CHANGE ORDER NO. 3
CITY OF BRYAN CEMETERY EXPANSION PROJECT
CITY JOB NO. 572-D5-1303

April 5, 2016

We are submitting Change Order No.3 to your contract for City Job No. 572-D5-1303. This change order provides for the following additions and deductions. All work to be performed in compliance with contract specifications.

SHEET NO.
C2.5

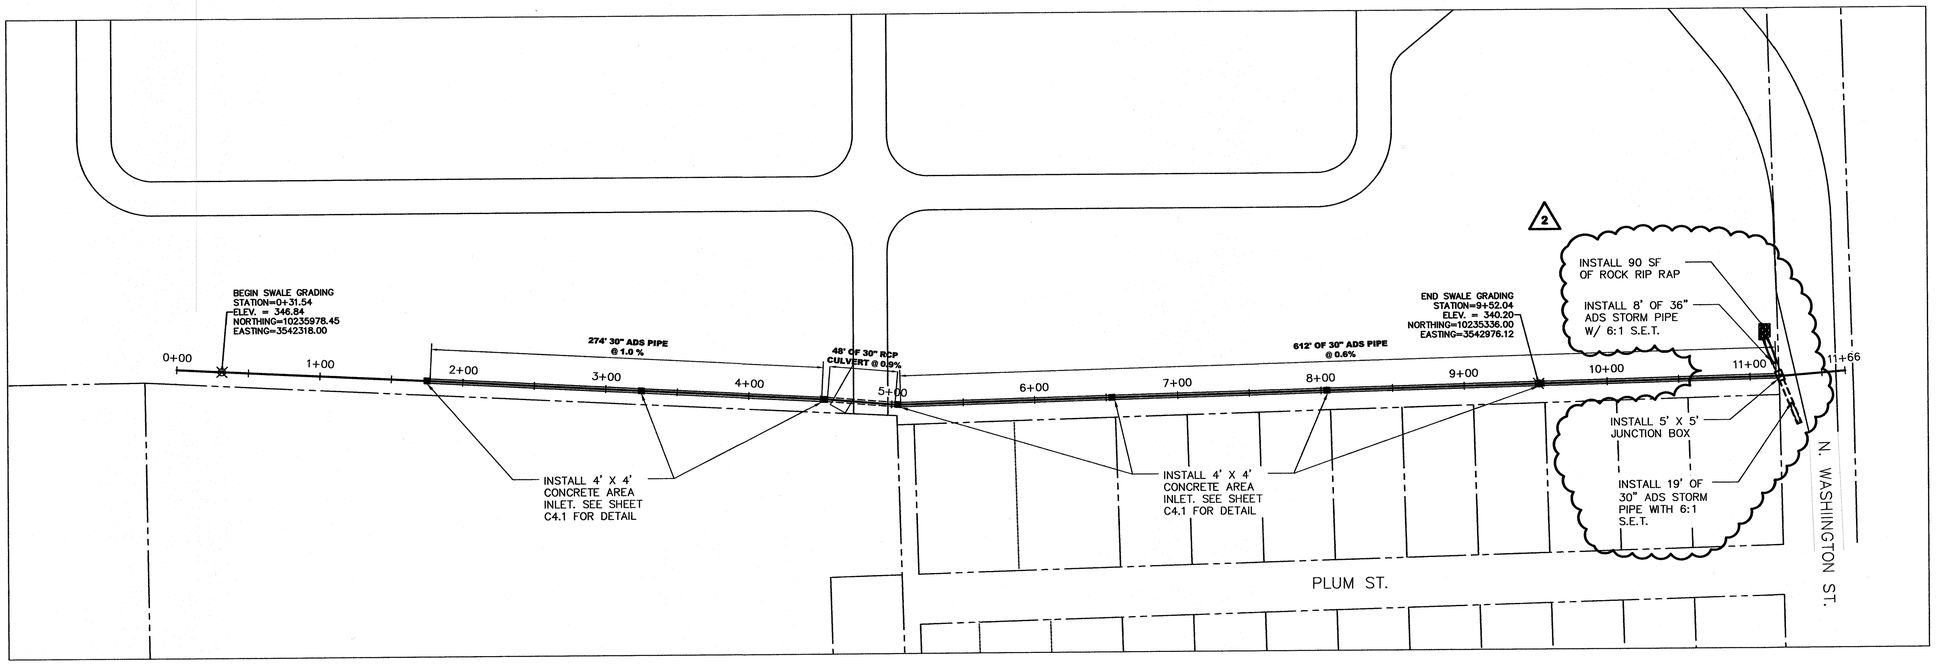
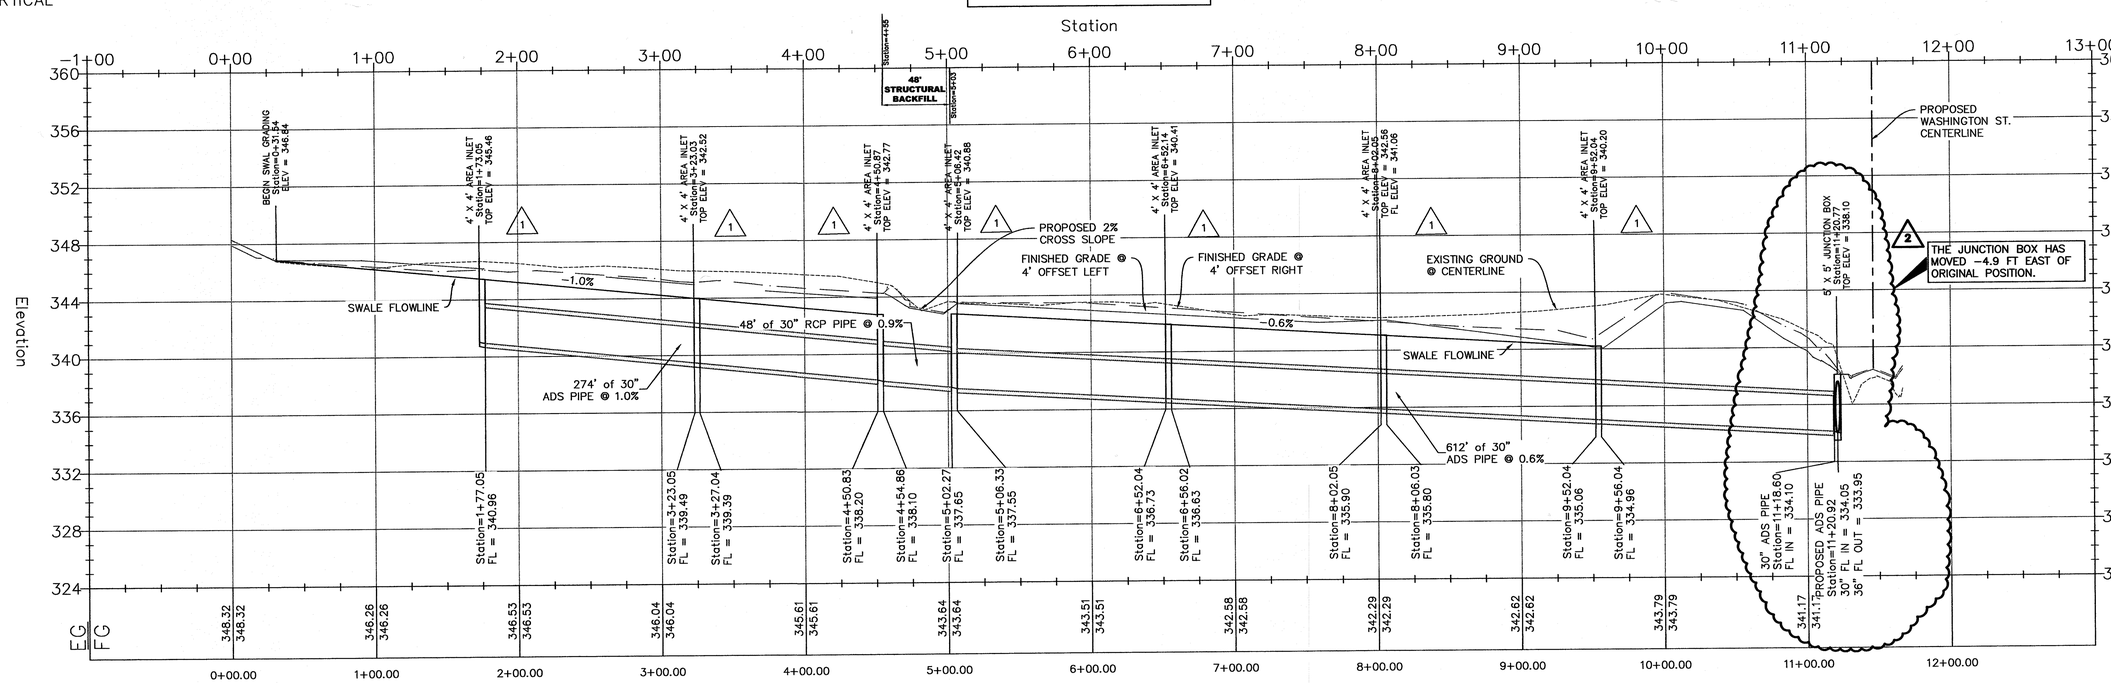
REV	DATE	DESCRIPTION
1	10/29/15	REVISION TO AREA INLET ELEVATIONS
2	03/16/16	STORM SEWER REVISIONS

SHEET NO.
C2.6

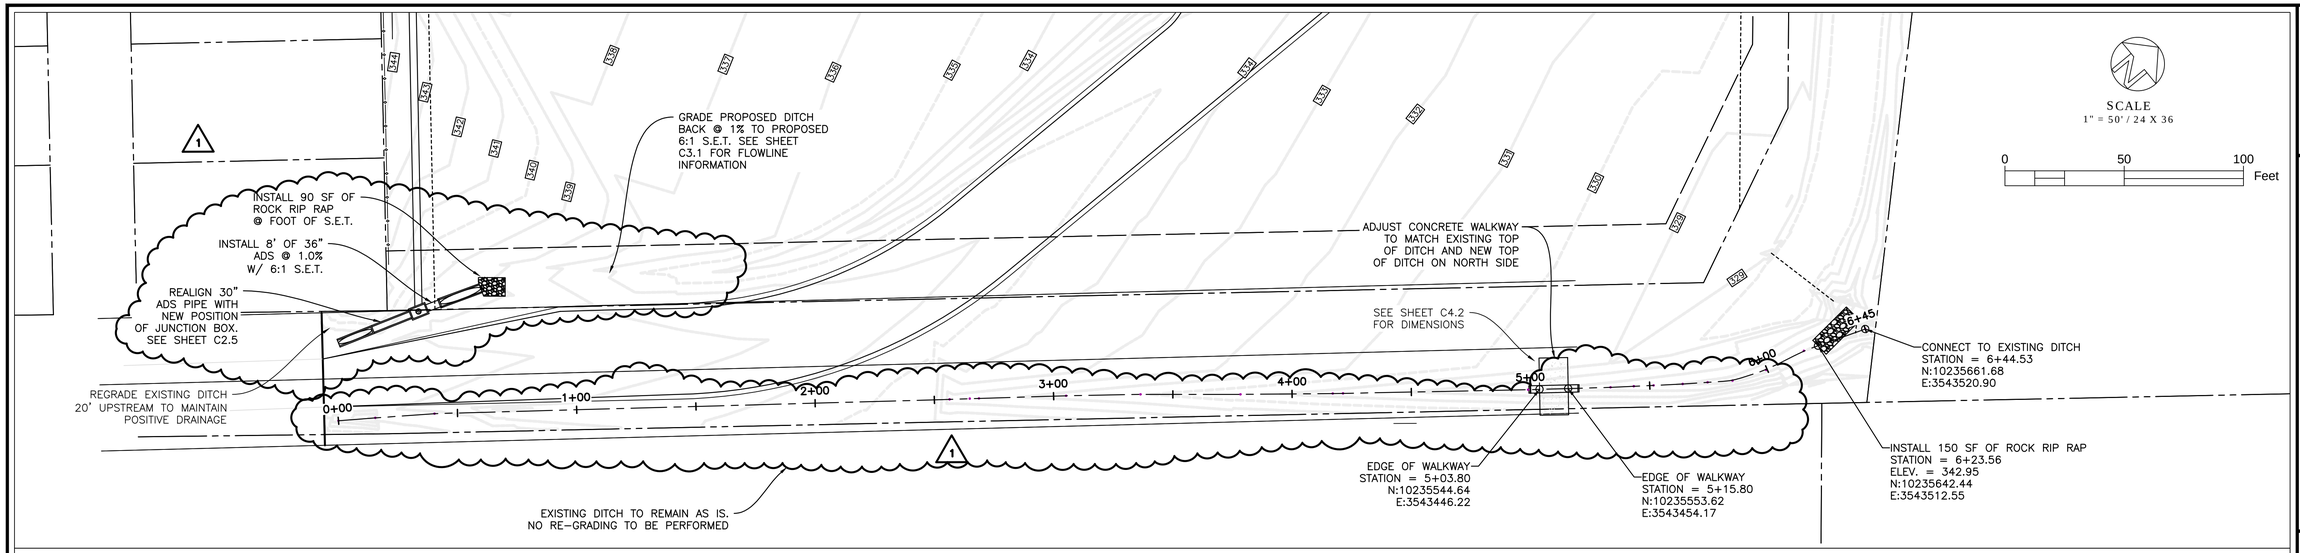
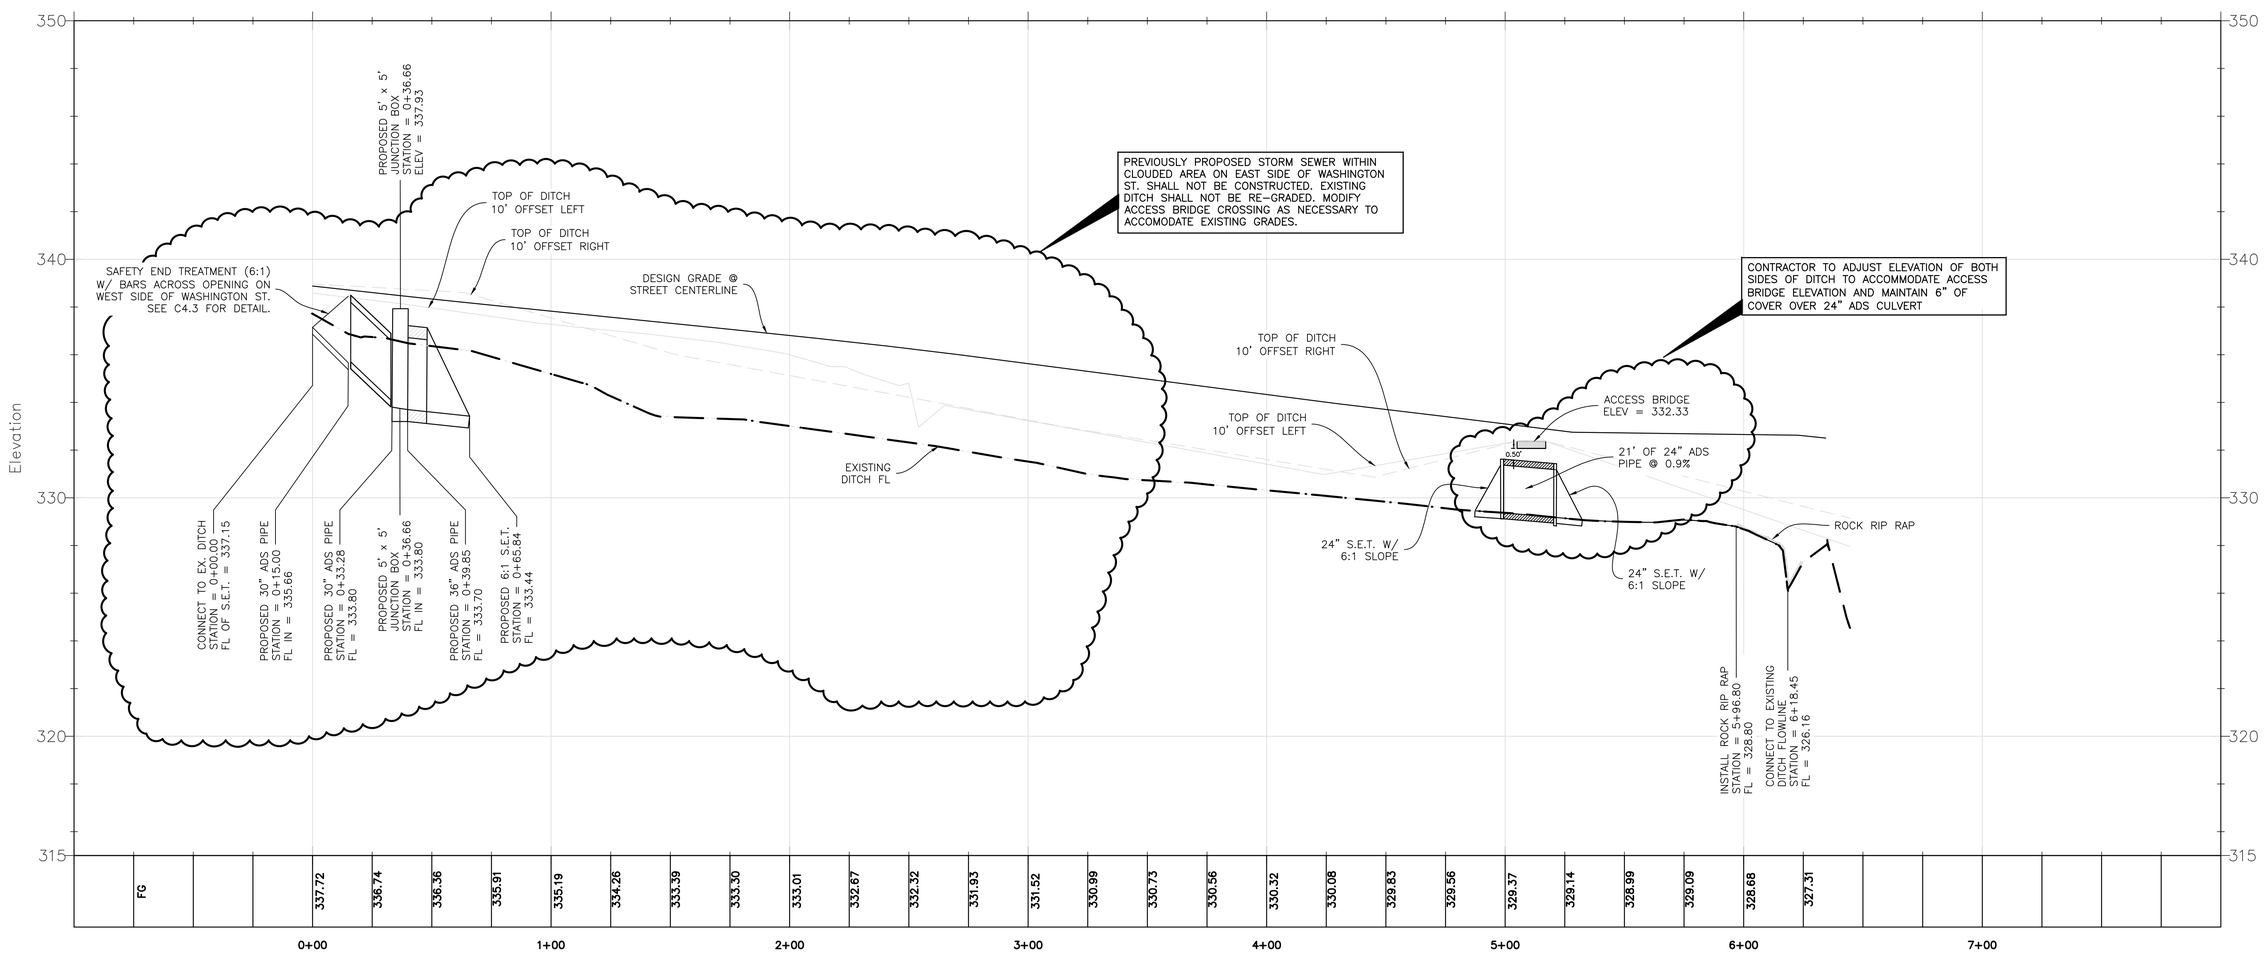
REV	DATE	DESCRIPTION
1	3/15/16	STORM SEWER REVISIONS

NO STORM SEWER OR ASSOCIATED ROCK RIP RAP PROPOSED ON SHEET C2.6 SHALL BE CONSTRUCTED EXCEPT FOR THE CULVERT @ THE ACCESS BRIDGE CROSSING. PROPOSED ROCK RIP RAP @ EXISTING OUTFALL SHALL REMAIN. MODIFY ACCESS BRIDGE CROSSING AS NECESSARY.

SHEET NO.
C3.1

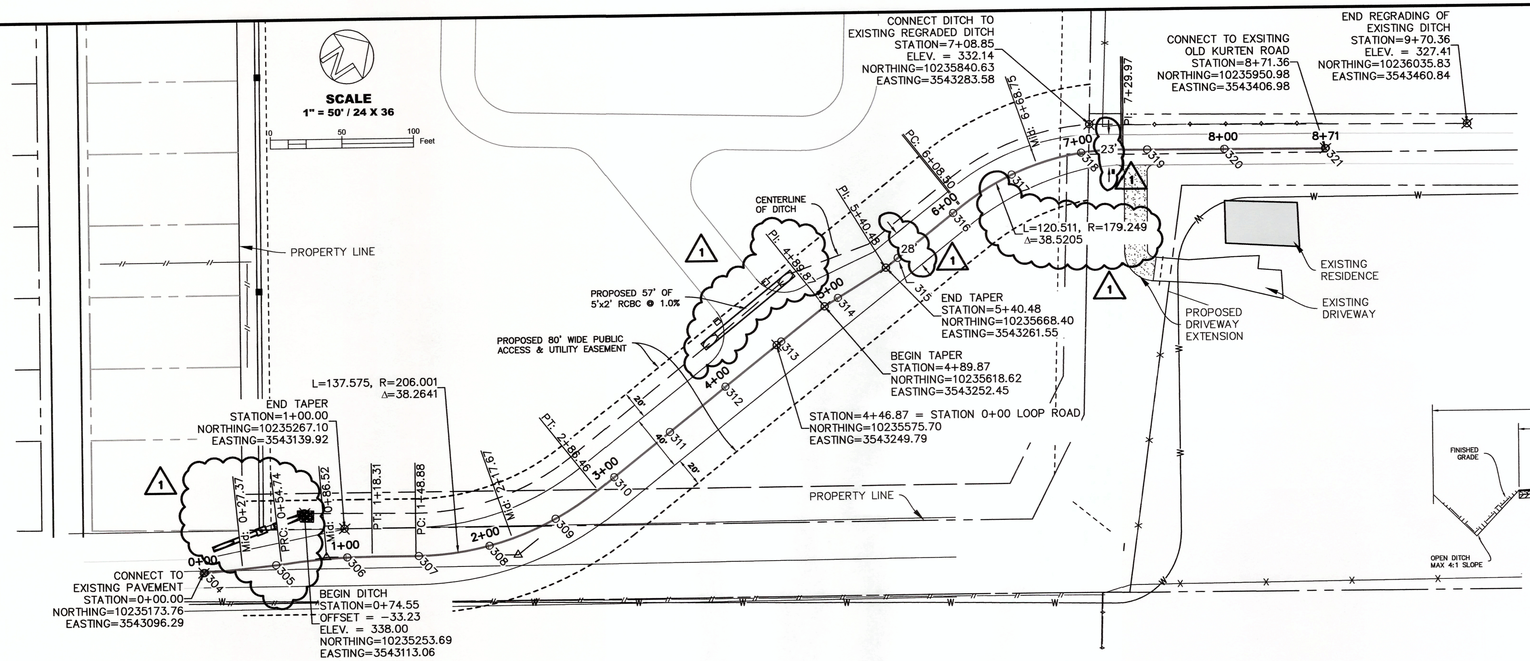
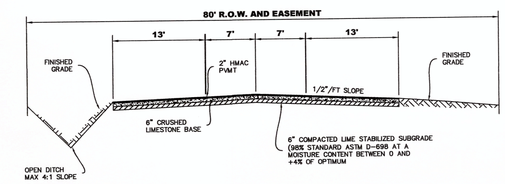
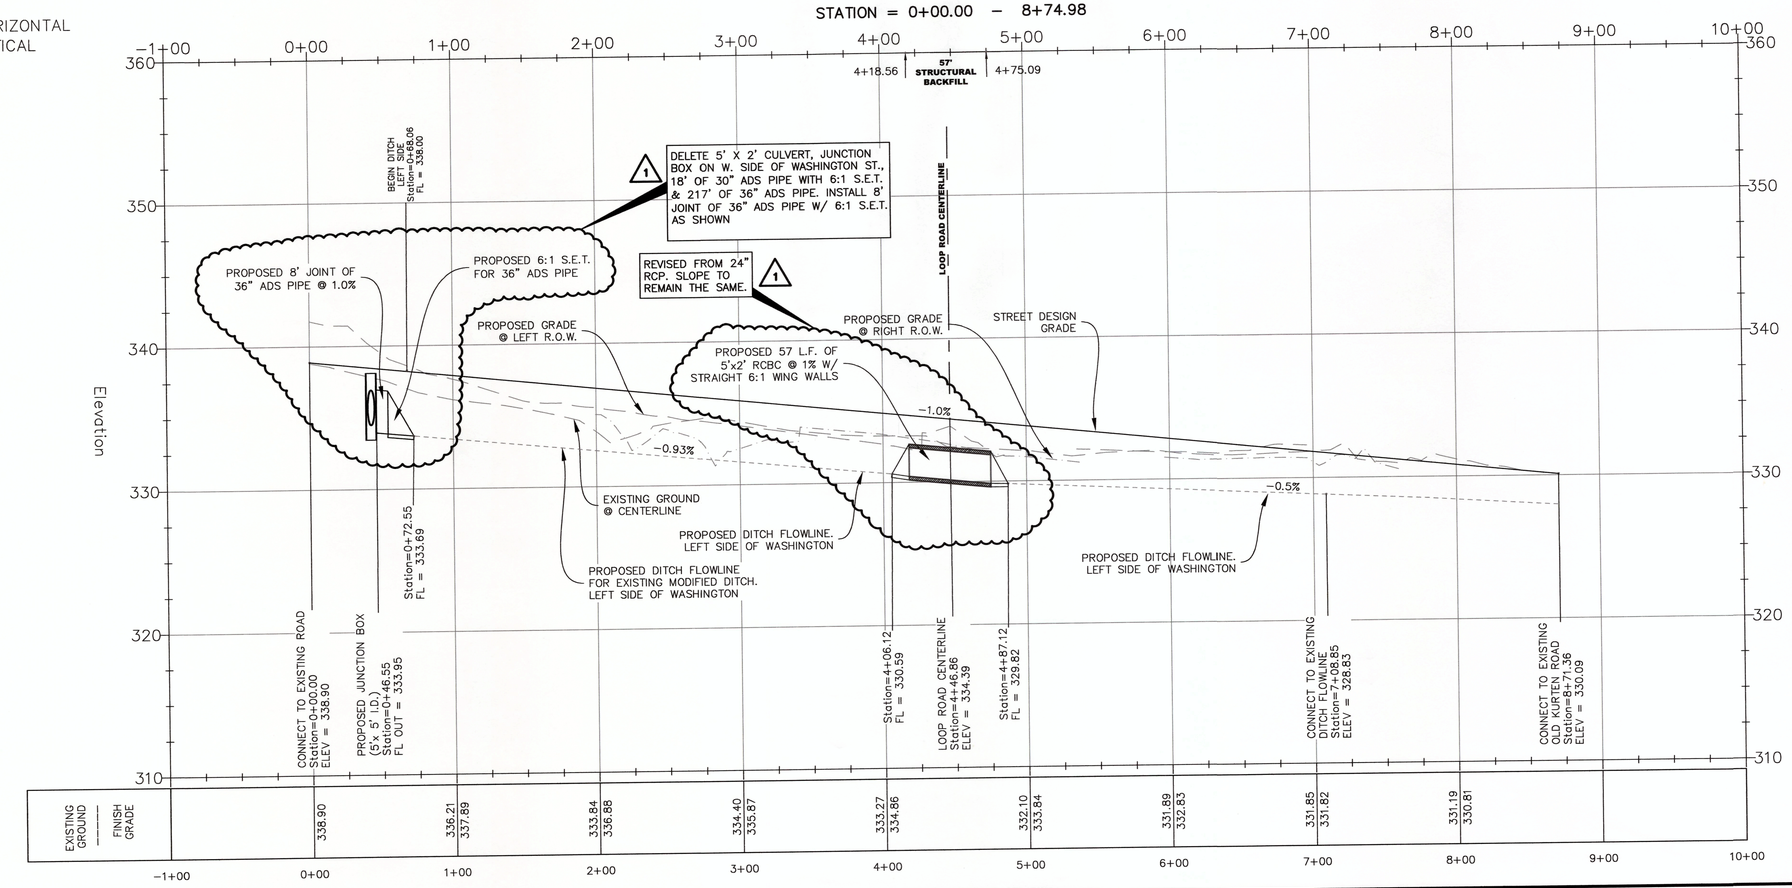
A. **Add: 12"-3% cement stabilization, 8" flexible base for Washington Road in accordance with recommendations from Geotechnical Investigation. Connection apron from Kurten to the new Washington Realignment and turn assist at end of road for future development of area NE of Kurten Road. New items for drainage re-design required due to conflict with water line discovered during construction.**

REV	DATE	DESCRIPTION
1	3/17/16	STORM SEWER REVISIONS & ADDITIONAL DIMENSIONS
